Our ref.: 70014753

Subject: 53 Fitzroy Park - Construction Traffic Management Plan Technical Review

| | DRAWING No: 7453-ATR-001 A | REV: A |

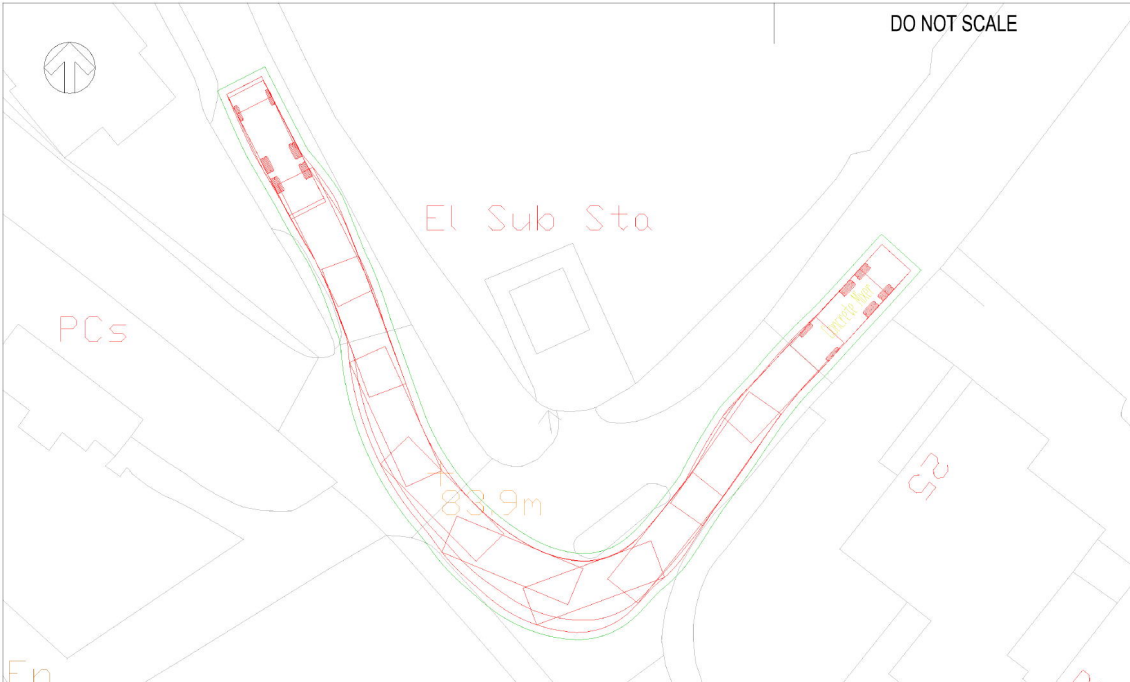
We wish to highlight the swept path analysis of an 8.8m vehicle negotiating the junction of Merton Lane and Millfield Lane presented in Motion drawing no.170512-TK06.

- The swept path analysis clearly shows this type of vehicle over sailing the footway of both Merton Lane and Millfield Lane;
- The analysis confirms there will be a clear risk to pedestrians who may be present on the footway at that location or approaching;
- Given the high containment kerbs protecting the traffic island on Merton Lane we anticipate the risk to pedestrians will be increased;
- Drivers, naturally prefer to avoid the above physical measures giving them a wider berth as they pass and are at greater risk of overrunning the Merton Lane and Millfield Lane footways as the only way of navigating the junction; and
- The above is not replicated in the swept path analysis and there is a lack of a reasonable offset in the swept path analysis provided.

WSP previously undertook an independent swept path analysis of an 8.36m concrete mixer (the largest proposed vehicle in the CTMP), entering and exiting Fitzroy Park from Merton Lane (refer enclosed 7453-ATR-001 drawing).

The WSP independent swept path analysis includes a clear buffer of 0.5 metres from any physical constraints to allow for such things as vehicle wing mirrors which extend outside the vehicle profile and provide a suitable margin for error or data inaccuracy, based on good industry practice.

The independent swept path analysis identified that there is a high risk of over running the existing footways as the concrete mixer navigates the Merton Lane junction.

| PROJECT No: | 70017453 | DRAWING No: | 7456-ATR-002 | REV: | B |

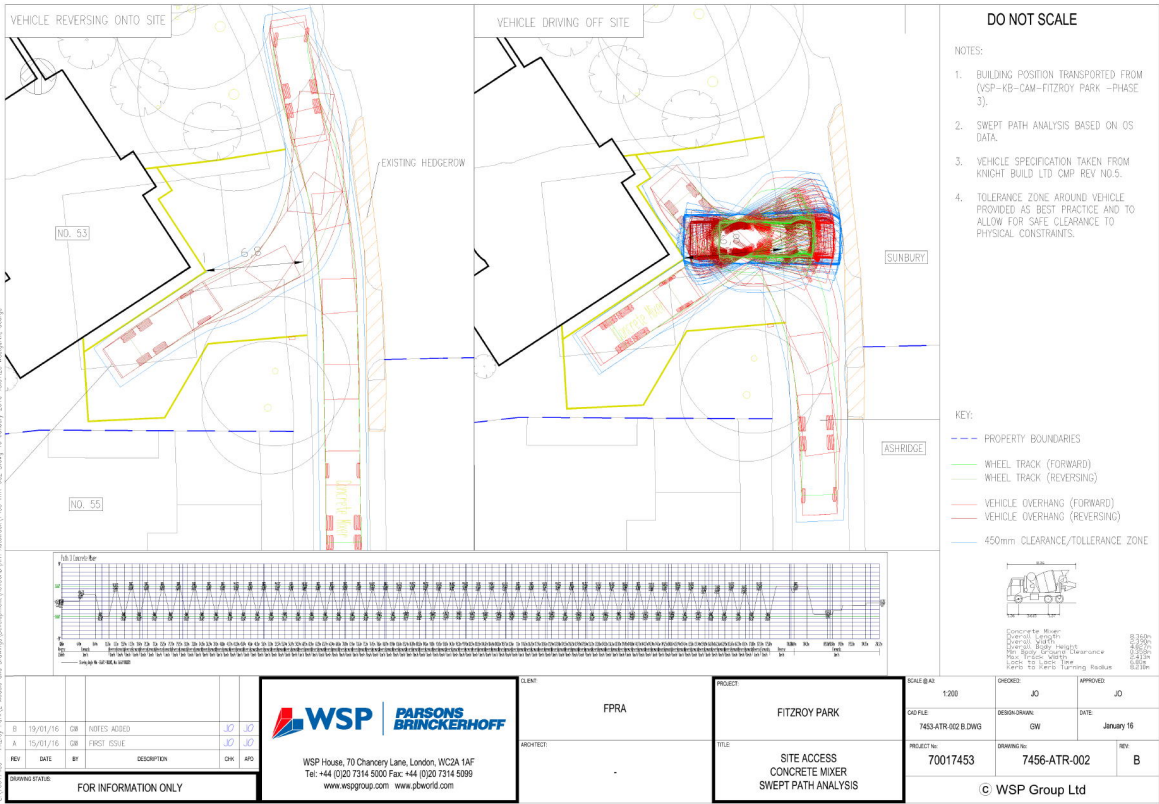
WSP have previously undertaken independent swept path analysis of an 8.36m concrete mixer (the largest proposed vehicle in the CTMP), entering and exiting the site from Fitzroy Park, as per the constraints and site arrangement for Phase 3 (refer enclosed 7453-ATR-002 drawing). The site constraints were taken from the Knight Build Ltd plans including the proposed building outline, extent of the loading area and existing trees. The site constraints were mapped into the base model prior to undertaking the Swept Path Analysis.

The WSP independent swept path analysis includes a clear buffer of 0.5 metres from any physical constraints to allow for such things as vehicle wing mirrors which extend outside the vehicle profile and provide a suitable margin for error or data inaccuracy, based on good industry practice. The analysis was completed with no use of 'turning on the spot' and used a driving speed of 1 km/hr in both directions.

The swept path analysis confirmed the following:

- It will take as many as 48 individual movements for the concrete mixer to be able to fully turn around and depart from the site;
- The chart at the bottom of drawing ATR-002 shows the distance travelled with each change in direction or alternating movement. It records a total distance travelled of 202m.

- Insufficient space for vehicles or pedestrians to pass the construction vehicle safely between individual movements;
- The analysis predicts it could take up to 13 minutes to complete the overall manoeuvre, but also does not factor in time for changing gears between movements which may further increase the duration;
- The space required to turn the concrete mixer around leaves little or no room for welfare, the storage of site material or contractors vehicles within the loading area.

The application of a sensible separation between the vehicle and any physical constraints when manoeuvring and omission of dry steering lead us to the fair and reasonable predication a greater number of movements than shown within the existing CTMP will need to be undertaken for the concrete mixer to unload, turn around and depart from site.

The greater number of movements will in turn lead to an increase in the duration Fitzroy Park is obstructed. We estimate for the largest of deliveries, this could be up to approximately 13 minutes.
